**ATTACHMENT 9****[EXTERNAL] Good Onward, Inc. Cannabis Facility**

RE: Good Onward Inc. Project

SCHOOLS CLOSEST TO GOOD ONWARD  
 NPS

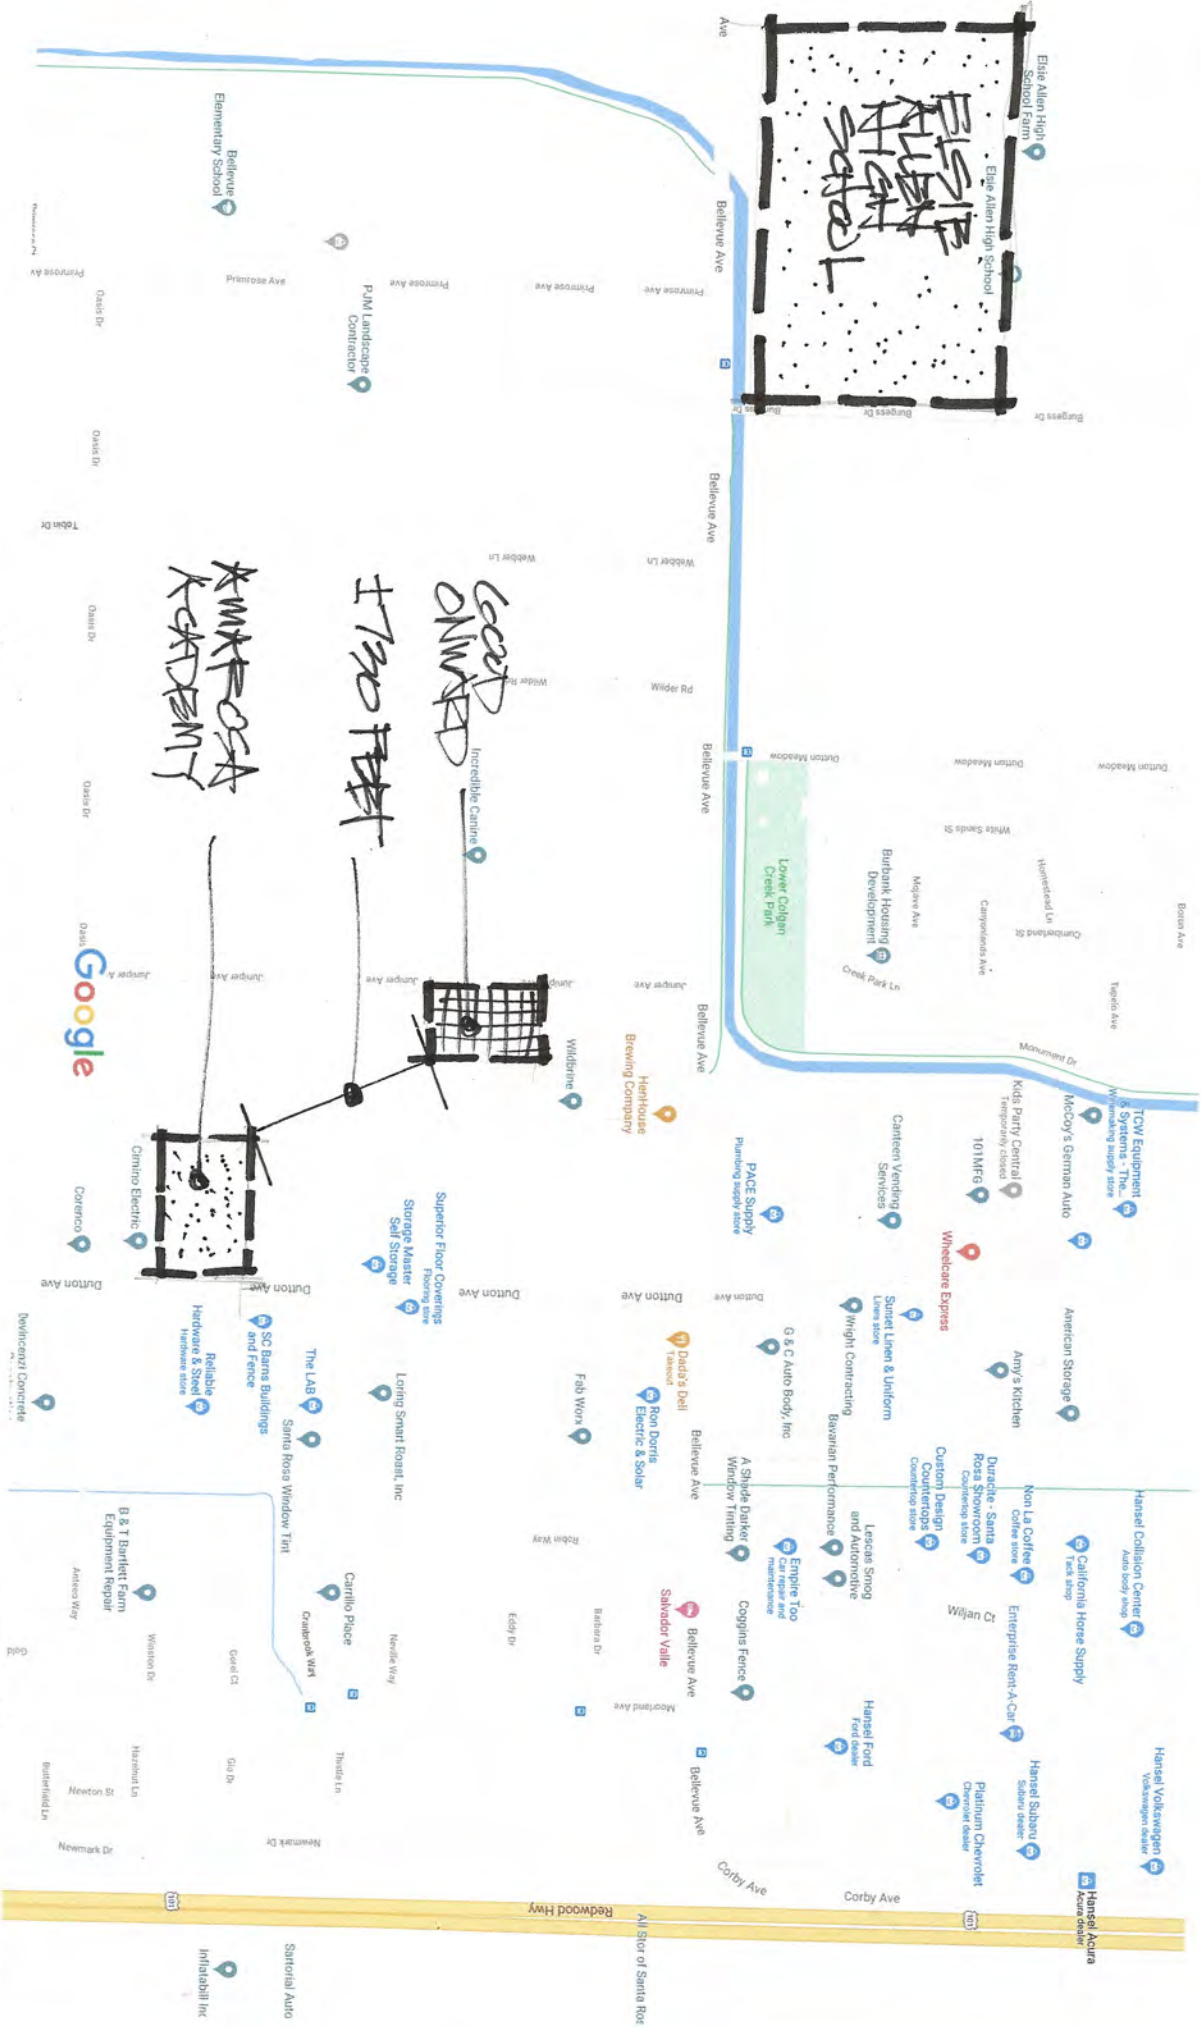
**3. Concern: “What about the two schools in such close proximity?”**

**Response:** As you are aware, the City Cannabis Code states; “Cannabis Retail shall be subject to a 600 foot minimum setback from any K-12 school”. The closest school to Good Onward is the Amarosa Academy on Dutton Ave. It is approximately 730 feet from the southeast property corner of the Good Onward property. This distance easily exceeds the required 600 foot minimum setback. The second closest school is Elsie Allen High School, further to the west along Bellevue Avenue. It is roughly 2000 feet from the Good Onward property, far exceeding the 600 foot minimum setback. A third school in the area is Meadow View Elementary, which is located on Dutton Meadow Ave., closer to Hearn Ave. This school also far exceeds to 600 foot minimum setback distance. I have prepared an exhibit entitled “Schools Closest to Good Onward” that shows the location of the first two schools in relationship to the Good Onward site. It is attached to this email.
